Letter R.B: Lisa Cottle, Winston & Strawn for Horizon West Transmission, LLC (January 12, 2022)**Letter R.B****WINSTON
& STRAWN**
LLP

By Electronic MailTrevor Pratt, c/o Tom Engels
Horizon Water and Environment
estrellaproject@horizonh2o.com**Re: Comments of Horizon West Transmission, LLC on the Recirculated Portions of the Draft Environmental Impact Report for the Estrella Substation and Paso Robles Area Reinforcement Project, November 2021 (California State Clearinghouse No. 2018072071)**

FIGURE 1: Outward Development parcel

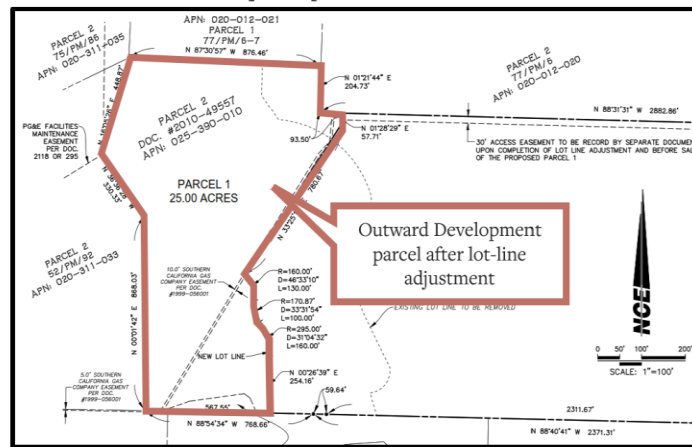
In July of 2021, we entered a Purchase and Sale Agreement (“PSA”) for a parcel of land with an APN of 025-390-010, which is currently planted as a vineyard. A condition of this purchase is a lot-line adjustment that would result in the existing 35-acre parcel being redrawn as a 25-acre parcel¹. These new boundaries are shown in Figure 1 below. Figure 2 highlights the relationship of this parcel to these transmission lines².

FIGURE 3: Additional power pole and line route modification

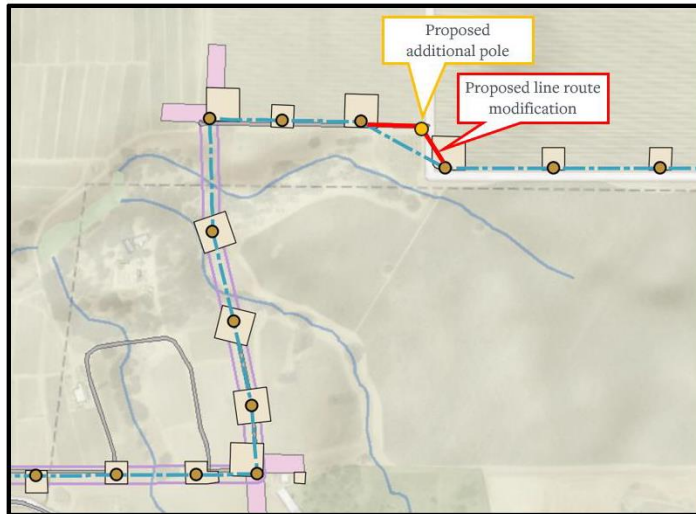
The fourth strategy would be to add an additional pole such that a transmission line does not needlessly cross a major portion of the property. An example is depicted in Figure 3 below. Under no circumstances will we support the sale of an easement through the middle of our property when such a simple and low-cost change could avoid millions of dollars of damages to our project, the city, and the community. If we are pressed to sell such an easement, we will expect to be compensated for the full present value of the damage this transmission line will cause our project.

This comment provides a fourth approach identified as "partial mitigation" to reduce the alleged impacts of the Proposed Project's new 70 kV transmission line segment to the commenter's property, which is to add an additional pole as indicated in the commenter's Figure 3 such that the transmission line would not cross a portion of the Outward Development property. This option appears reasonable but would need to be evaluated by PG&E.

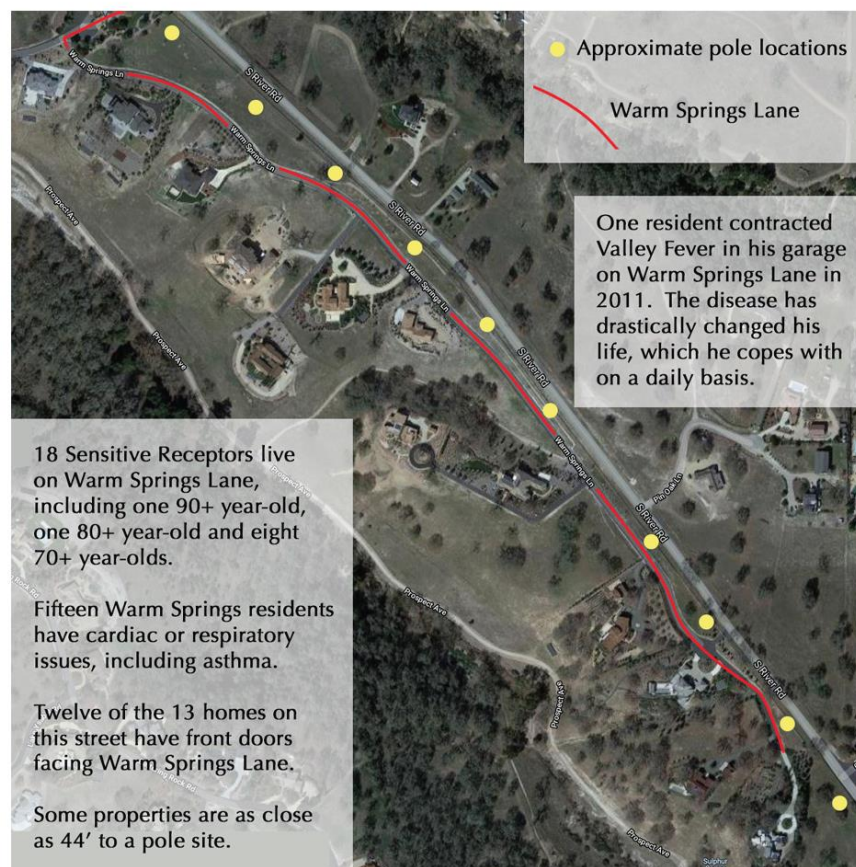
The RDEIR underestimates the health impacts of air quality due to proximity of the 13 homes on Warm Springs Lane. This street is the only way in and out for these residents. It is where they walk their dogs and walk to the mailbox. Avoiding repeated and prolonged exposure to soil disturbance areas is impossible as they live only feet away.

RDEIR 2-R.4.3-19: *"The calculated health effects are dependent upon the concentrations of pollutants to which the receptors are exposed, the number and type of exposure pathways for a receptor, and the intake parameters for a receptor, which vary based upon age and sensitivity (e.g., presence of pre-existing conditions). Health effects would be more likely for individuals with greater susceptibility to exposure, and the location of receptors relative to the project impacts would affect whether receptors are exposed to project-related pollutants."*

Air Quality- Sensitive Receptors, Fire Rock Loop / Santa Ysabel Ave. 2

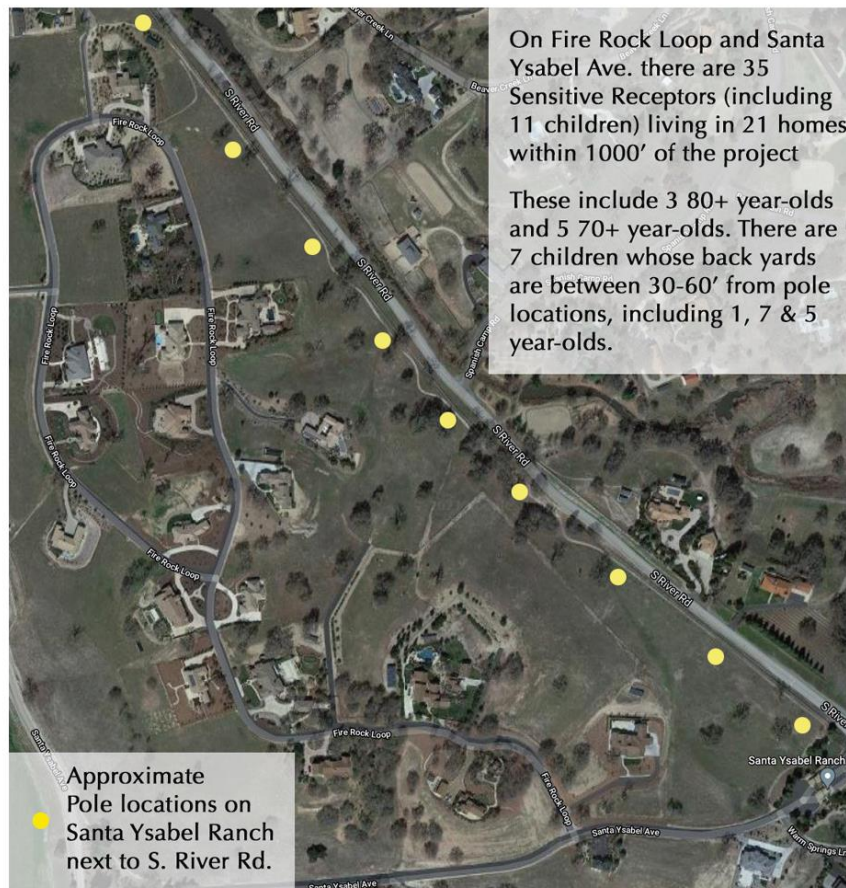
Revised DEIR 2-R.4.3-19: "Health effects would be more likely for individuals with greater susceptibility to exposure, and the location of receptors relative to the project..."

There are 21 homes (within 1000' of proposed pole locations) on Fire Rock Loop and Santa Ysabel Ave. Thirty five of those residents are Sensitive Receptors with cardiac and respiratory health issues, including 14 and 15 year-olds with severe asthma. On Fire Rock Loop there are 3 homes with 7 children between the ages of 1-17. Their backyards are between 30-60' from the proposed pole locations.

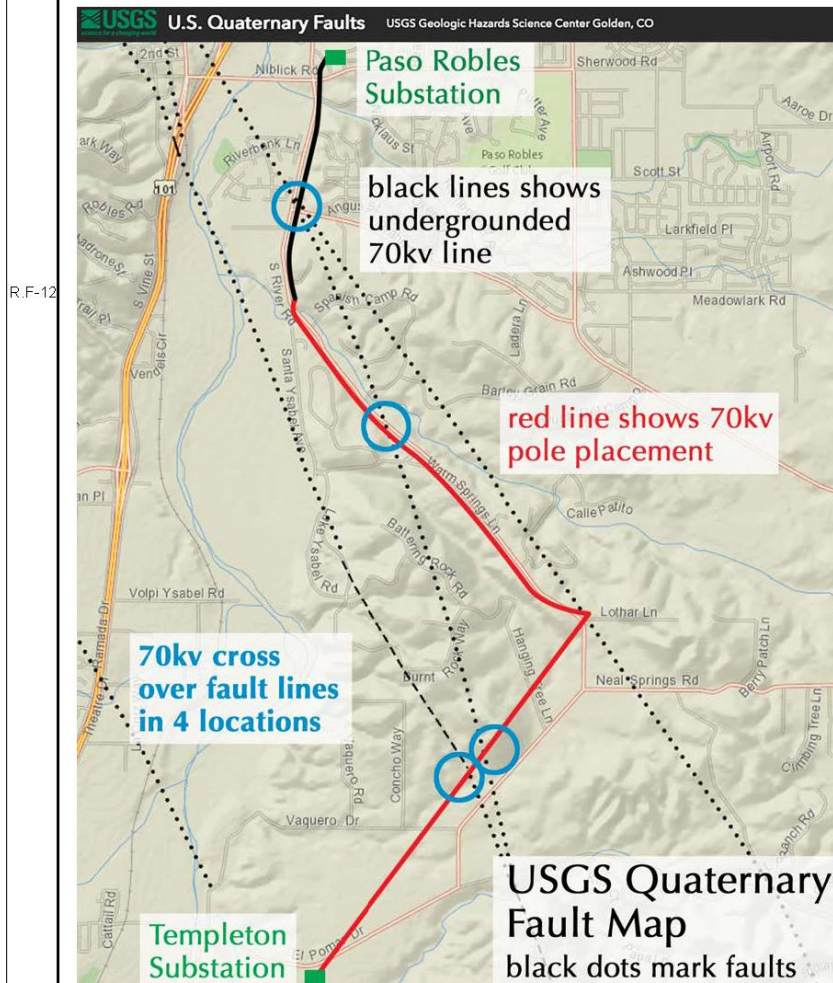
"Examples of locations that may contain sensitive receptors include residences, senior living complexes, schools, parks, daycare centers, nursing homes, and medical facilities."

- Daycare Depot, a child-care center 525' away
